**DEFENSE NUCLEAR FACILITIES
SAFETY BOARD**

Staff Issue Report

April 21, 2016

SUBJECT: Savannah River Site Nuclear Criticality Safety Program

Figure 1: The SRNS Approach to ANSI/ANS-8.1 Process Analysis Compliance

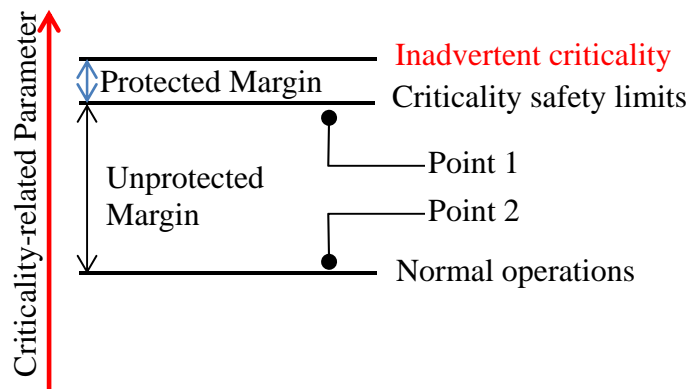
The SRNS process does not prohibit operation near criticality safety limits (Point 1 in Figure 1), though in practice, HB-Line and H-Canyon operations are conducted well below criticality safety limits (Point 2 in Figure 1). The staff team is concerned that the SRNS criticality safety program does not establish appropriate margin in criticality safety limits. The staff team reviewed a subset of SRNS operations that apply margin to criticality safety limits in order to account for measurement, equipment, and process uncertainty. The SRNS criticality safety program and implementing procedures do not require this practice, however, and the staff team notes that it is not uniformly applied by SRNS.

The staff team believes that the SRNS methodology would be better aligned with the ANSI/ANS-8.1 process analysis requirement if appropriate, defensible safety margins were included in criticality safety limits. Safety margin should be identified based on an evaluation of the process so that credible control failures do not result in an inadvertent criticality. As a result, criticality safety limits would be set closer to normal operating conditions. This proposed methodology is described in Figure 2.
